ASHLAND PLANNING DEPARTMENT
PRE-APPLICATION CONFERENCE
COMMENT SHEET
March 16, 2023

SITE: 710 Ashland Creek
APPLICANT: Rouge/Asher for Sidwell
REQUEST: Physical & Environmental
Constraints Review Permit for Hillside
Development

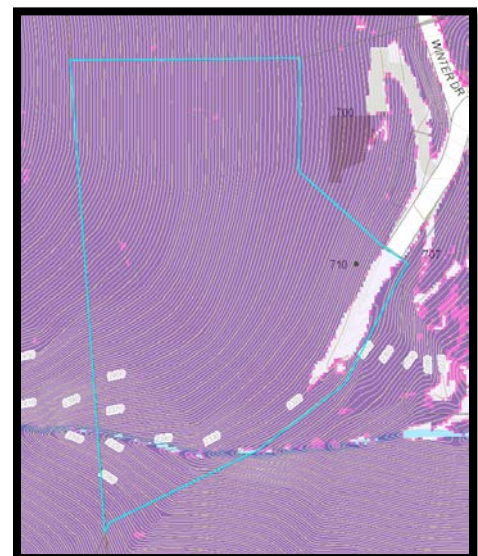
The property located at 710 Ashland Creek is a steeply sloped lot. Virtually the entire lot is ‘severely constrained’ (slopes greater than 35%). On the image below (generated by City GIS) the dark magenta are slopes greater than 35% (typically there is light magenta showing slopes greater than 25%, however this entire lot has an average steepness of 55% - discussed further below).

Staff is concerned about the required depth of excavation based on the proposed location of the house. A cut fill analysis will be required to demonstrate compliance with the grading standards.

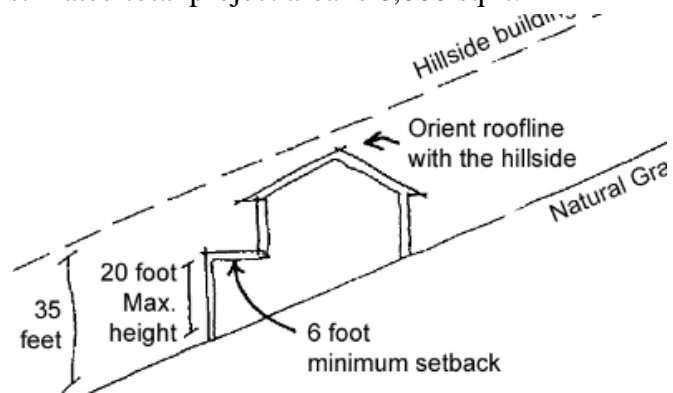
Building Design: Staff has concerns regarding the building design with regard to the following hillside standards From AMC 18.3.10.90.E.2.:

- Deck projecting out from the structure goes against the hillside standards.
- Roofline does not orient with hillside.
